## ADDENDUM NO. 04

<b>PROJECT:</b>	<b>Auburn Park Full Build-Out Montgomery County, VA Parks and Recreation</b>
<b>GNI Job No.:</b>	<b>2893.00</b>
<b>DATE:</b>	<b>Friday, March 15, 2024</b>

**3 ELEVATION**  
A101 1/4" = 1'-0"

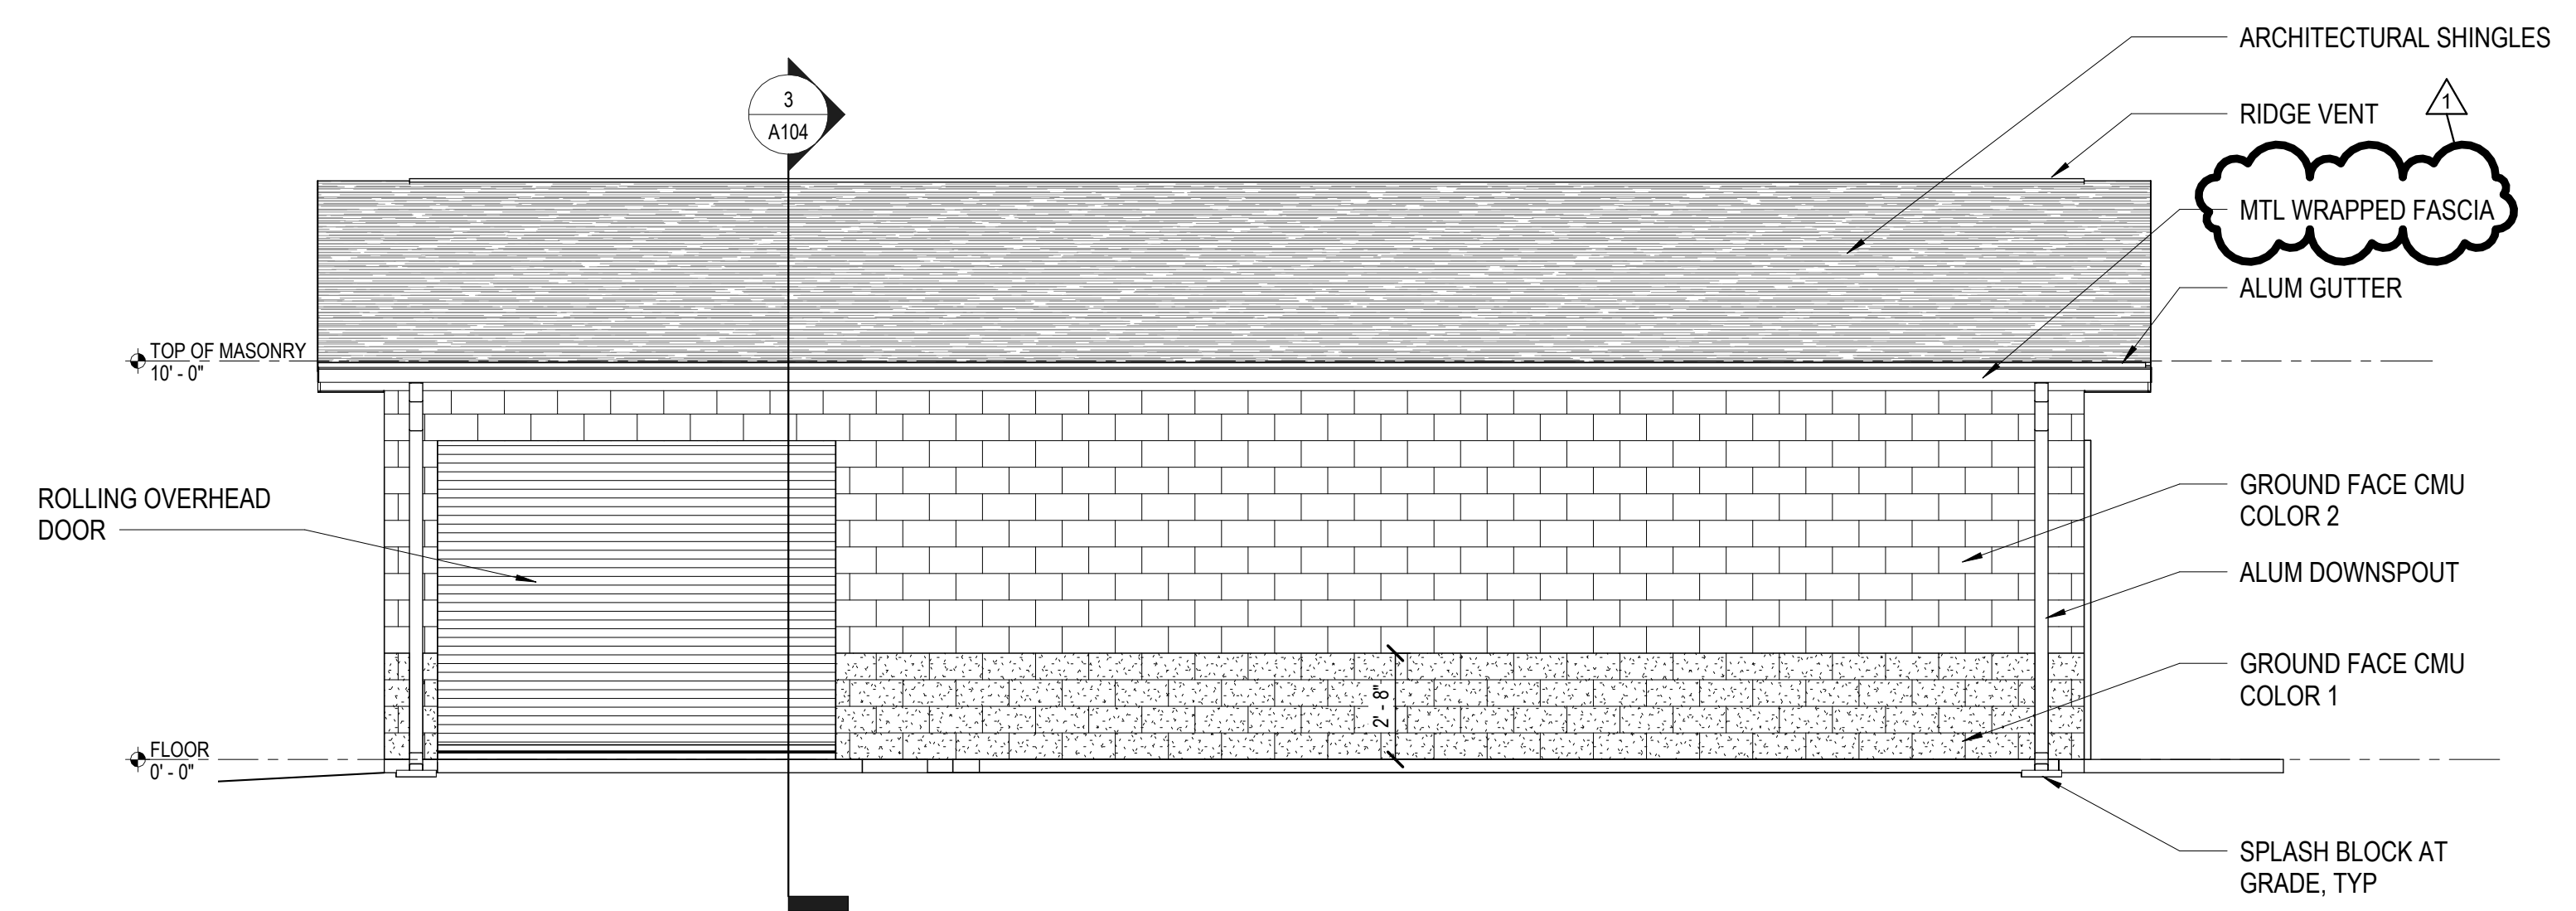
**REVISE** Labels calling for “PVC FASCIA” on all elevation views on this sheet to read as follows:  
“MTL WRAPPED FASCIA” as shown in attached revised Sheet A102 with revision date 3-14-24.

BUILDING SECTIONS -  
RESTROOM BUILDING

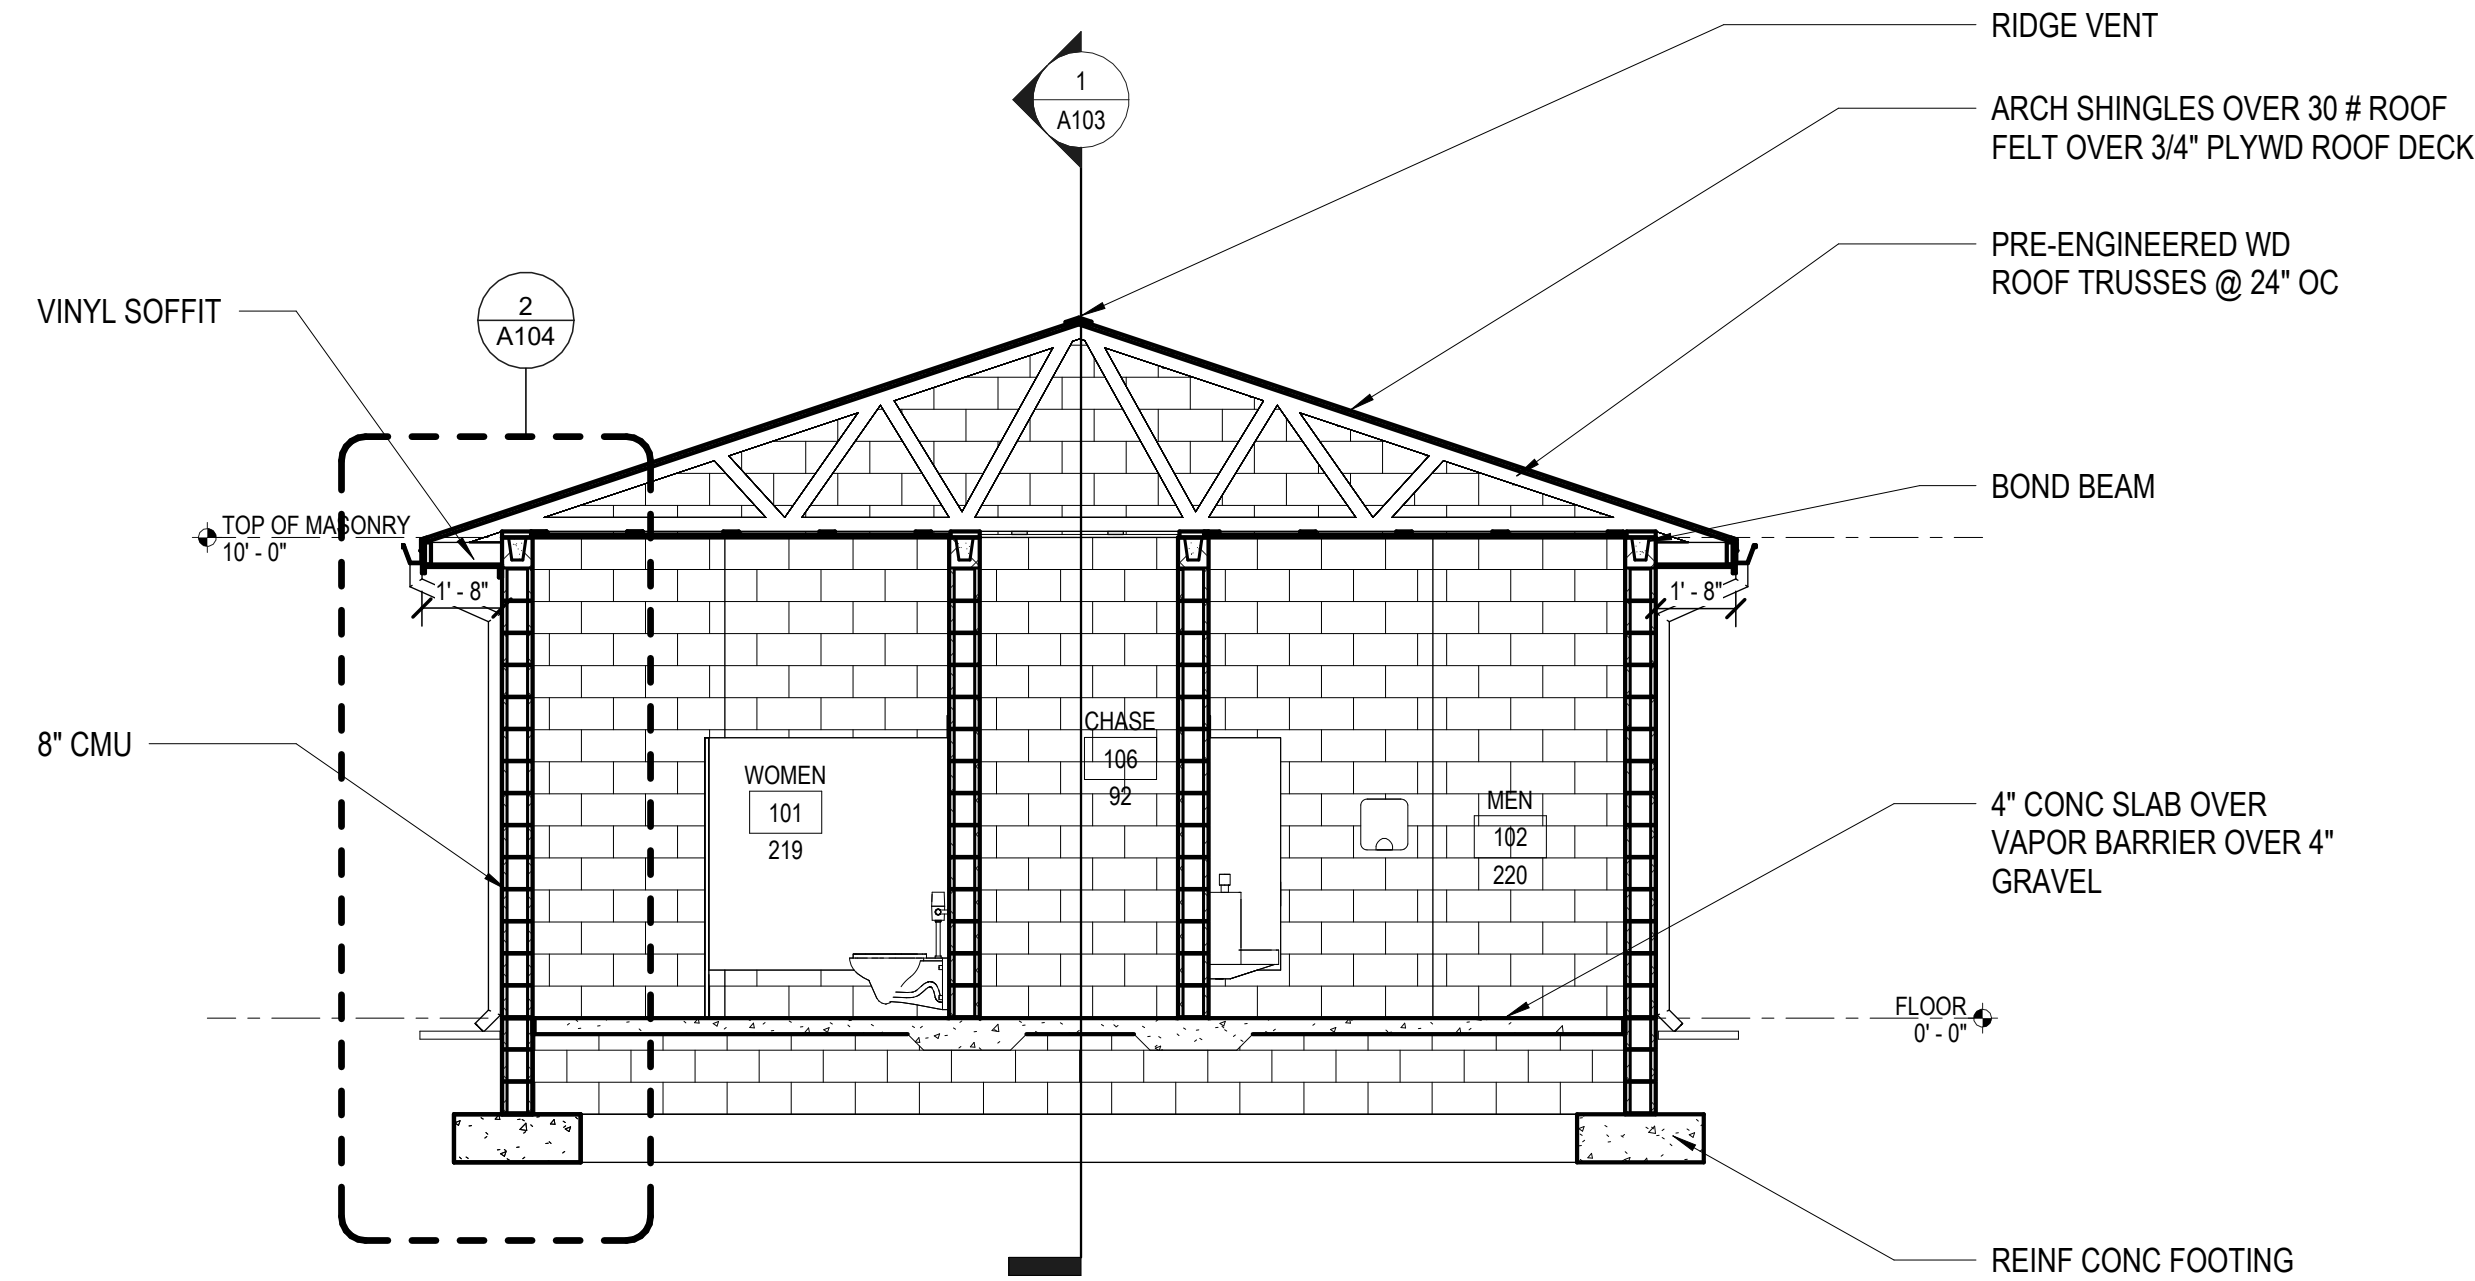
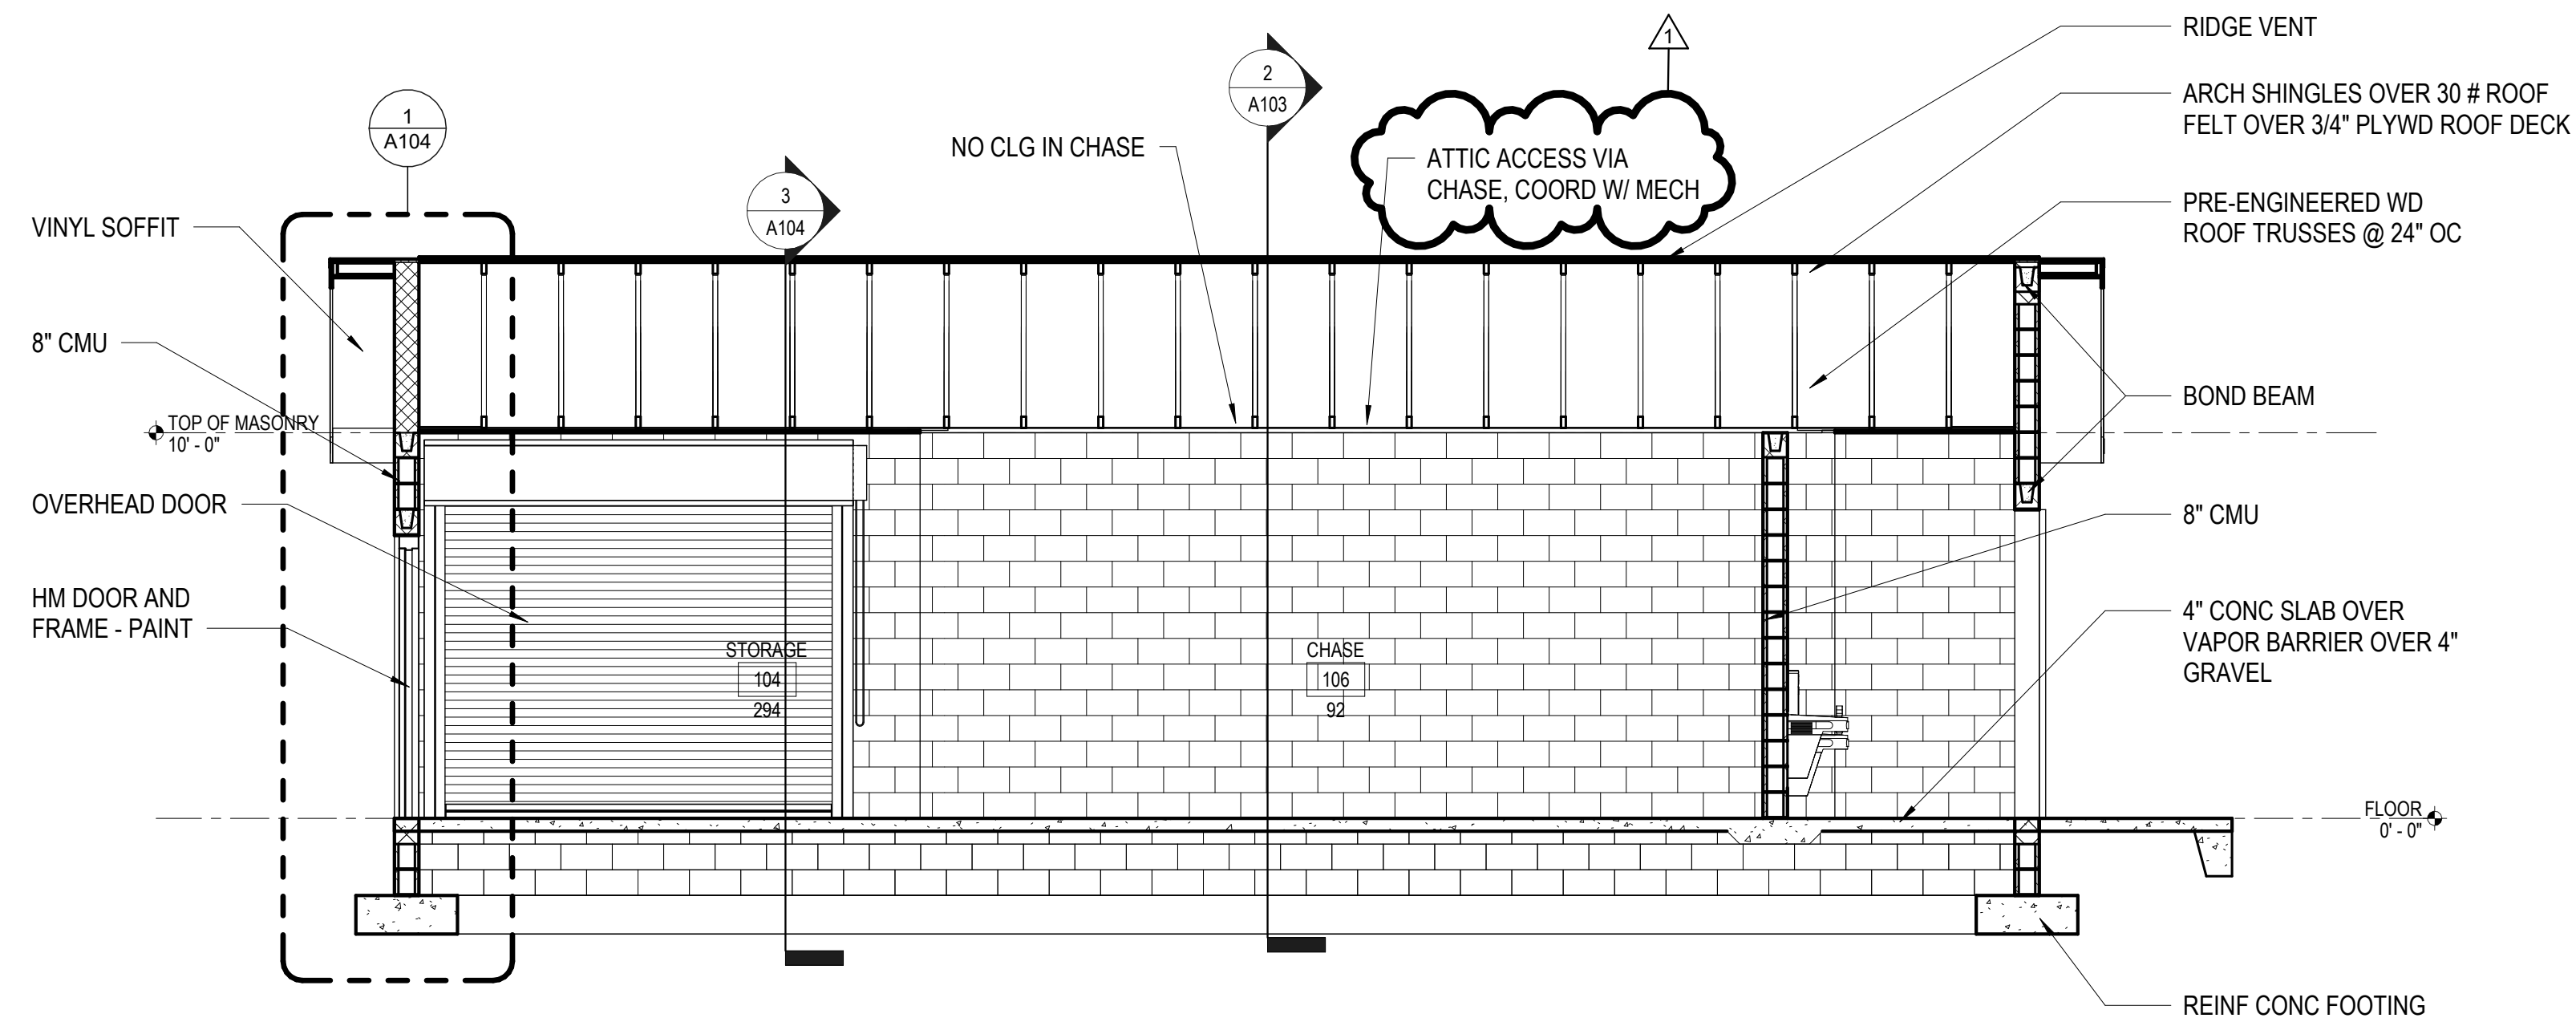
**ADD** label for “ATTIC ACCESS VIA CHASE, COORD W/ MECH” in chase area as shown in attached revised Sheet A103 with revision date 3-14-24.
